## **Environmental Impact Statement**

### **Southern California Edison's West of Devers Upgrade Project**

### **Comments and Responses**

**U.S. Department of the Interior  
Bureau of Land Management**

Figure 1. Status Quo Location of Towers and Power Lines and proposed location of Tower 6N38.

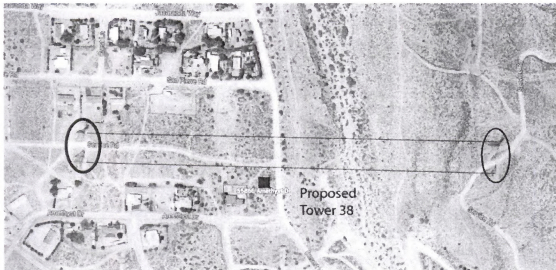
There has been some confusion as to the geography of the status quo and the proposal, so allow me orient you to the geography of the area.<sup>1</sup> This view from Google Maps illustrates the status quo and the proposed location of Tower 6N38 (Figure 1). My house is at the bottom center of the photograph (marked by the icon). There are no houses to the east of mine or immediately across the street, and there are several houses to the west. There are several large vacant parcels to the north, separating my house from those on San Pierre Road. In between is a service road, used by SCE to tend to the existing transmission towers. My property line ends at the service road north of my house. There are two sets of SCE towers in the immediate neighborhood. They are marked by red ovals in Figure 1. They are both a considerable distance from my home, and the cables that are strung between them (represented by the red lines) are 50 feet or more behind my house and hang over empty land. Compare this to the red square near my house. This is where SCE proposes to locate Tower 6N38. Placing a tower there represents a radical departure from the status quo. There is a large corridor of desert scrub between

dwelling through which SCE could string its cables without locating a tower next to my home, but it prefers to locate it next to my home.

E29-1 This comment describes the location of a property relative to the Proposed Project. This residential property is on Amethyst Drive near Desert View Avenue in Whitewater. The existing transmission corridor abuts the rear of the property. The proposed tower of concern is 6N38, shown on Figure AP.2-26 in Appendix 2, Detailed Maps.

While the Proposed Project has preliminarily located the tower at the position shown in Figure AP.2-26, final engineering may result in an adjusted position. The EIS also includes two alternatives affecting tower locations in the Whitewater area, the Phased Build Alternative and the Tower Relocation Alternative. If adopted, the Phased Build Alternative would retain existing double-circuit towers and replace the existing single-circuit towers with new double-circuit towers. (See Appendix 5. (Alternatives Screening Report), Section 4.2 (Phased Build Alternative) and Figure Ap5-5a.) The Tower Relocation Alternative would shift some proposed towers further from the edge of the right of way. (See Appendix 5, Section 4.2 (Tower Relocation Alternative) and Figure Ap.5-3h, which shows the location of the relocated Tower 6N38, shifted north of the proposed location.) The CPUC and BLM will determine the final approved project, which may be the Proposed Project or alternatives to the project, or a combination of both.

Figure 2. S8866 Amethyst Drive and proposed location of Tower 38.

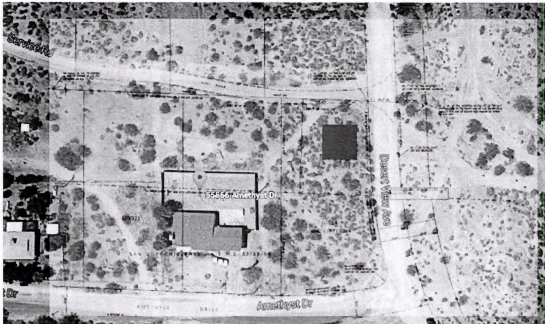
A closer view of the location of my house with respect to the proposed Tower 38 is visible in Figure 2. This figure is a composite of the Google Maps satellite image overlaid with a document provided to my neighbor Corinne Slusser (Exhibit Map APN 517-211-015\_Slusser\_Property.pdf). My house and the fence around my backyard are clearly visible. As anyone can see, the new tower and the fencing surrounding it will occupy roughly one-half of my neighbor's property and render it unbuildable. It will tower over my house destroying the view I currently enjoy of the local mountains and desert from my backyard. The cables strung between the towers will dangle and sway over my roof and backyard whenever the wind picks up, which is often since this is located in the San Geronio Pass. The noise will make my backyard unusable, and the transmission towers and the cables will be an eyesore.

Figure 3. The view from my backyard and what it would look like with Tower 6N38.

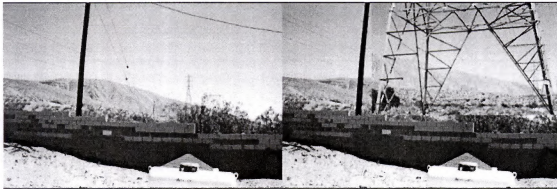
considerations to me as an artist and to potential buyers who desire that aesthetic. In order to demonstrate the effect it will have, I have simulated it photographically (Figure 3).

F4-4

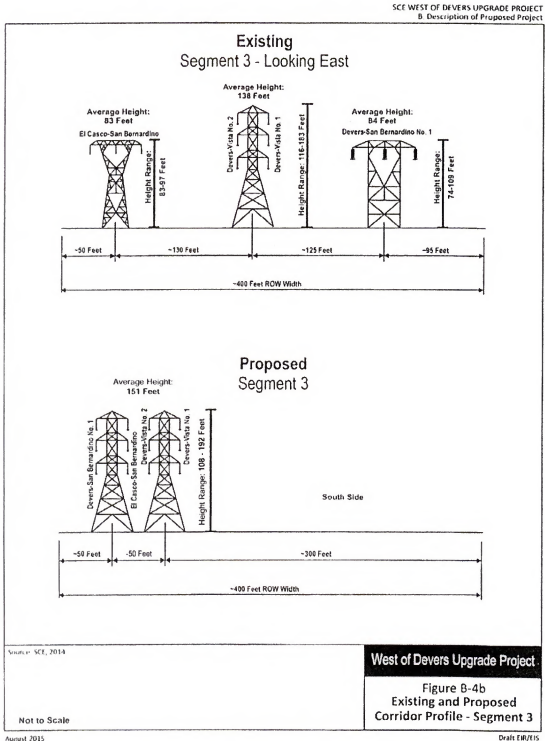
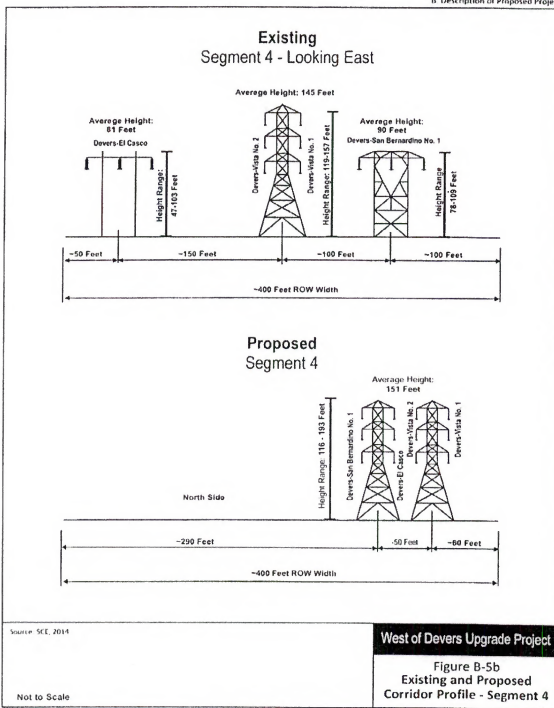
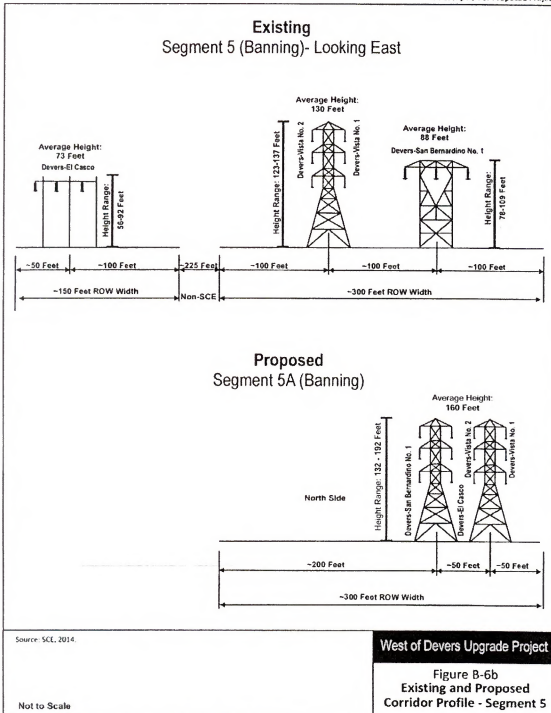
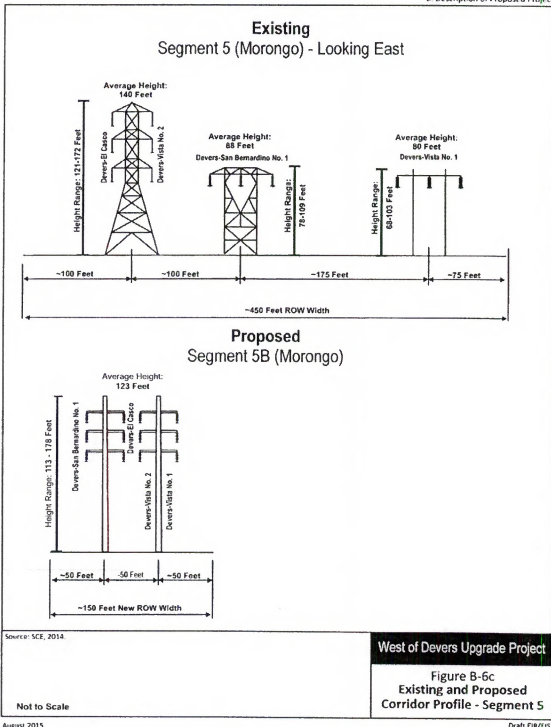
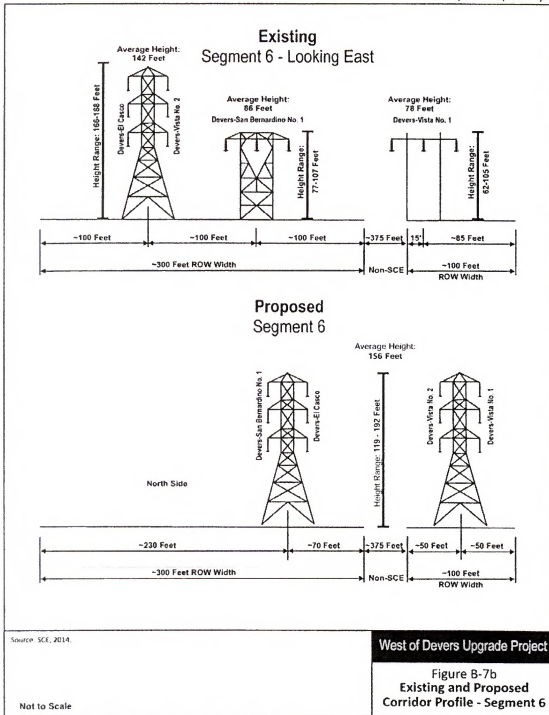
**Figure B-2b**

Please see attached file “WODUP\_Figure B-2b\_Rev.pdf” updating Figure B-2b.

- F3-83 The commenter has submitted as an attachment an updated Figure B-2b (Existing and Proposed Corridor Profile – Segment 1) for inclusion in the Final EIS. The figure has been updated in the Final EIS. Please see Response to Comment F4-4.

- Figure B-2b (Existing and Proposed Corridor Profile – Segment 1),
- Figure B-3b (Existing and Proposed Corridor Profile – Segment 2),
- Figure B-4b (Existing and Proposed Corridor Profile – Segment 3),
- Figure B-5b (Existing and Proposed Corridor Profile – Segment 4),
- Figure B-6b (Existing and Proposed Corridor Profile – Segment 5),
- Figure B-6c (Existing and Proposed Corridor Profile – Segment 5), and
- Figure B-7b (Existing and Proposed Corridor Profile – Segment 6).

F4-4  
cont.

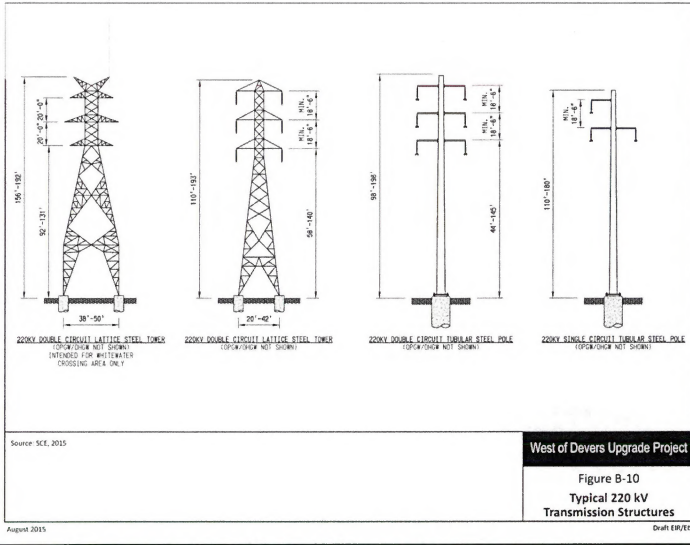
**Figure B-10**

Please see attached file “WODUP\_Figure B-10\_Rev.pdf” updating Figure B-10.

- F3-84 The commenter has submitted as an attachment an updated Figure B-10 (Typical 220 kV Transmission Structures) for inclusion in the Final EIS. The figure has been updated in the Final EIS. Please see Response to Comment F4-5.

F4-5 The commenter has provided a revised Figure B-10 (Typical 220 kV Transmission Structures). Therefore, Figure B-10 has been updated in Section B (Description of the Proposed Project) of the Final EIS, as also addressed in Response to Comment F3-84.
